ACCESSION NBR: 8202230353. DOC. DATE: 8/1/12/18. NOTARIZED: NO DOCKET #  
 FACIL: 50-397 WPPSS Nuclear Project, Unit 2, Washington Public Power 05000397  
 AUTH. NAME: BOUCHEY, G.D. AUTHOR AFFILIATION: Washington Public Power Supply System  
 RECIP. NAME: SCHWENCER, A. RECIPIENT AFFILIATION: Licensing Branch 2

SUBJECT: Forwards responses to Auxiliary Sys Branch Questions, 010.043 & 010.054 & Instrumentation & Control Sys Branch Questions 031.117, 031.118 & 031.128. Responses will be incorporated into FSAR amend.

Subject: NUCLEAR PROJECT NO. 2  
RESPONSES TO REQUESTS FOR INFORMATION

HACS P&ID

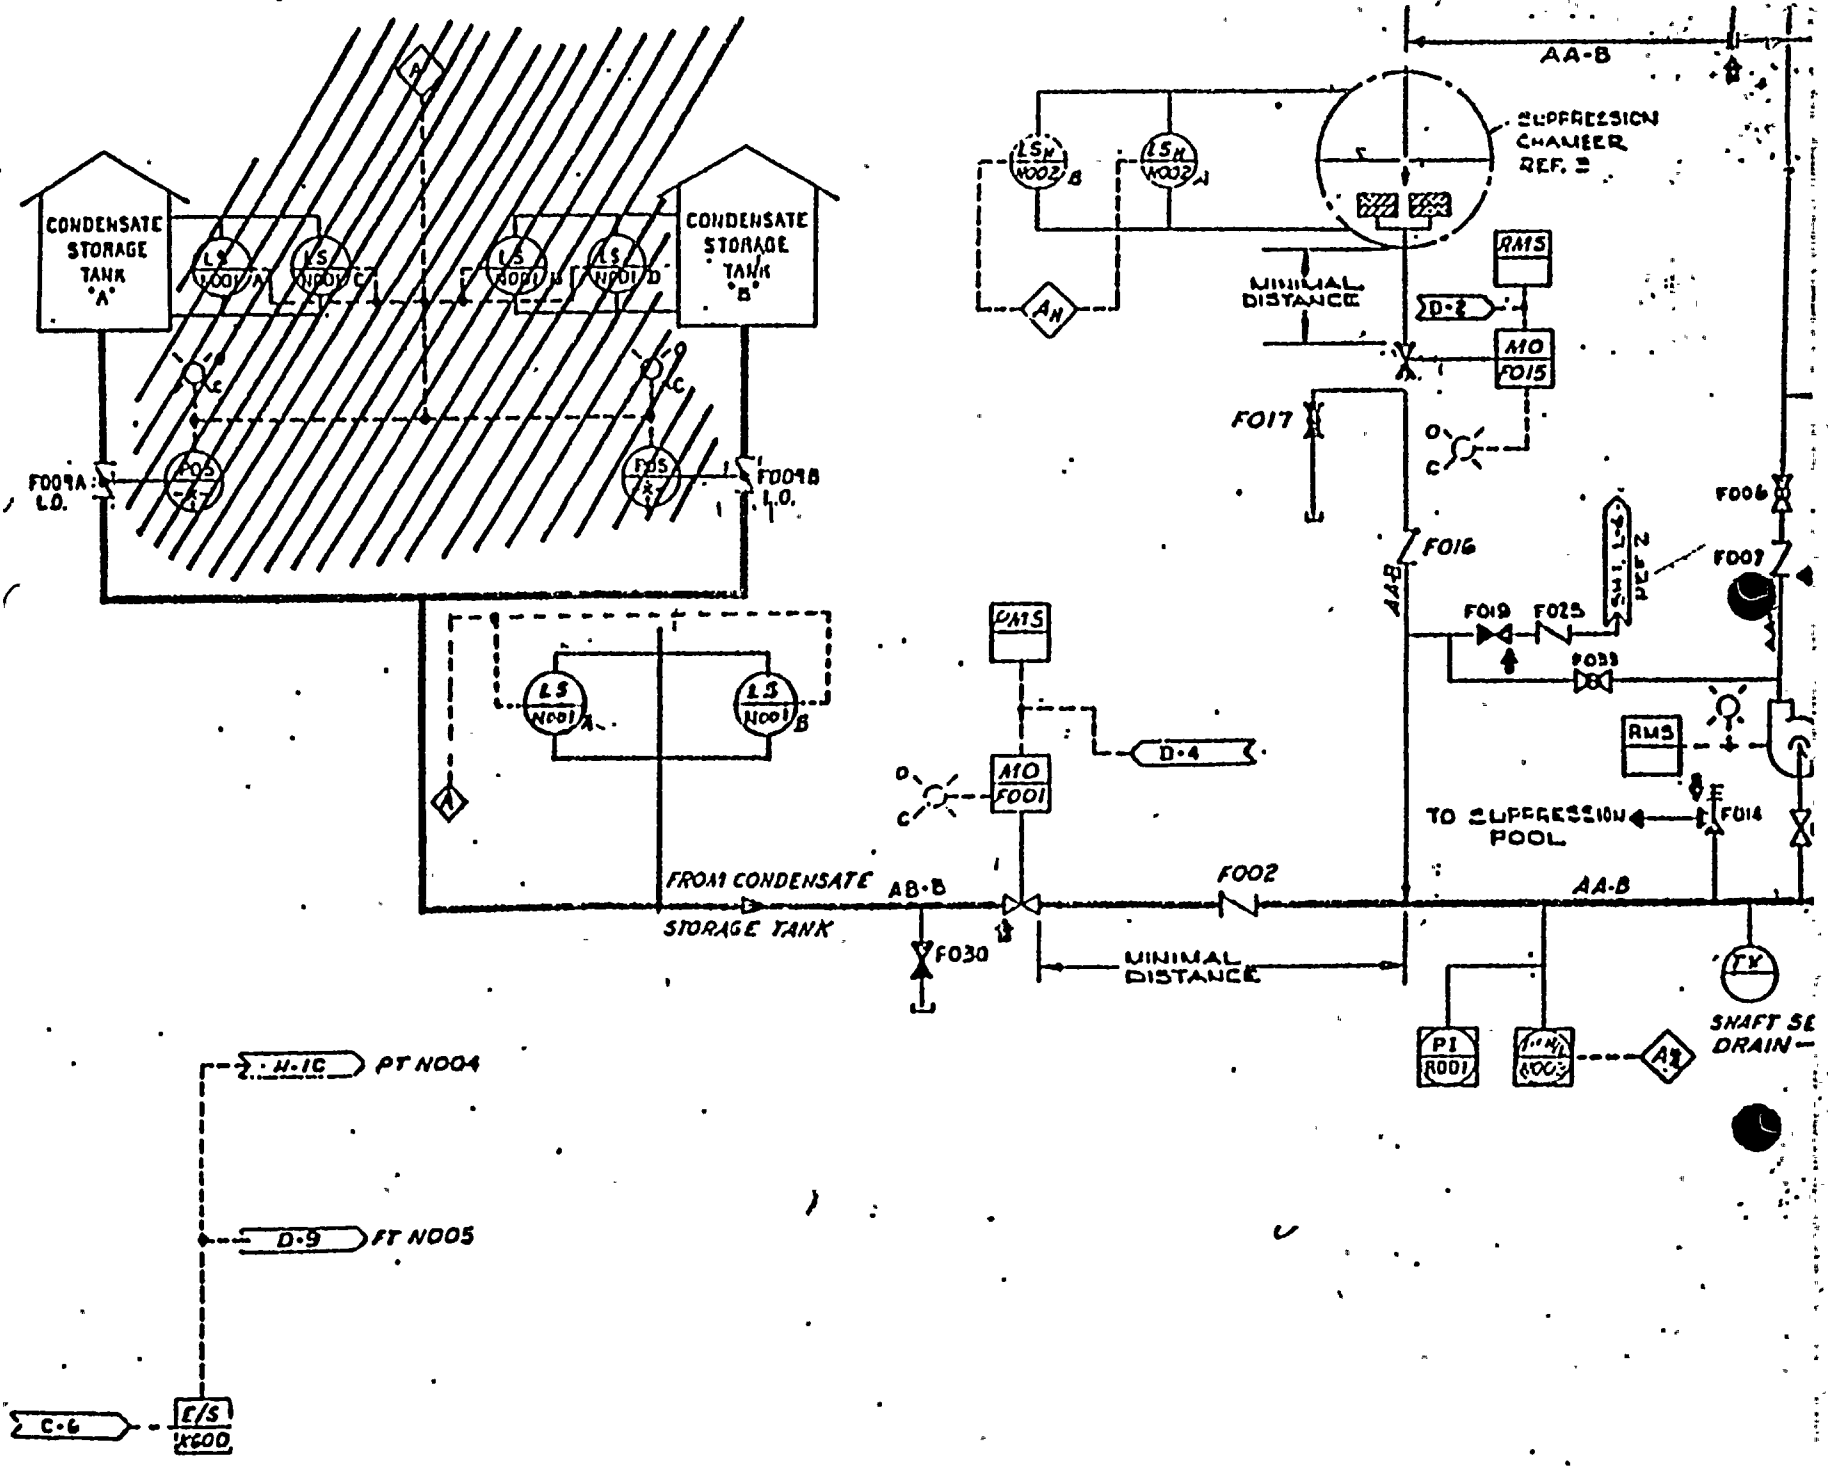
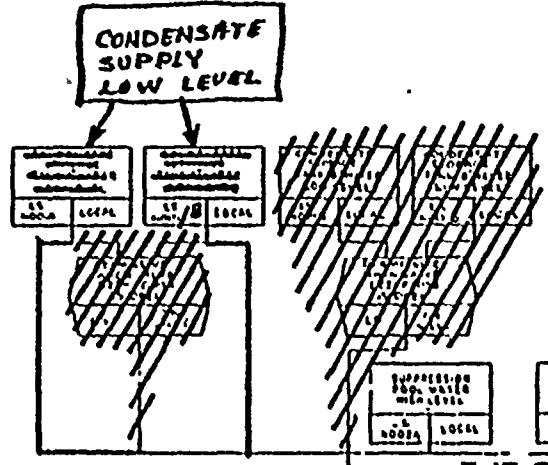
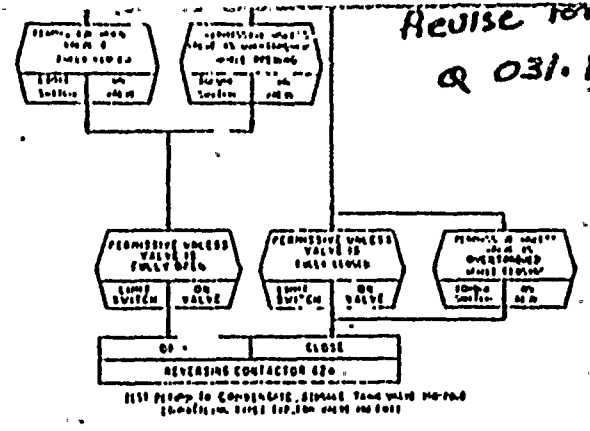
Figure 7.3-7 of the FSAR indicates that there are two condensate storage tanks, each with a manually operated discharge valve. The functional control diagram (i.e., Figure 7.3-8) illustrates, and the text discusses, the interlock between the condensate storage tank and the suppression pool suction valves which is intended to provide assurance that the high pressure core spray (HPCS) system pump has an acceptable supply of water at the suction inlet. However, if both manual discharge valves were to be closed, the purpose of this interlock would be defeated. Accordingly, provide justification in section 7.3.1.1.1 for the omission of manual discharge valve position switches as initiators in the HPCS pump suction control logic.

FSAR Figure 7.3-7 has been changed to Figure <sup>manual</sup>6.3-1 and Figure 7.3-8 has been changed to Figures 7.3-8a, 7.3-8b, and 7.3-8c. These figures have been revised to delete the ~~manual~~ discharge valve position interlocks. These interlocks were originally provided (when the condensate storage tanks level switches were physically mounted on the tanks) to prevent premature transfer of the HPCS suction to the suppression pool when one of the tanks was out of service (drained) giving a false transfer signal.

Figure 6.3-1 has been revised to indicate the level switches on a Class 1 standpipe in the Reactor Building on the condensate supply line to HPCS which is downstream of the manual suction valves. (These valves are locked open during normal operation.) With this modification, valve position interlocks are no longer required. FSAR Section 7.3.1.1.1 has been revised to correctly describe this modification.

Revise 10/1/68  
 Q 031.128
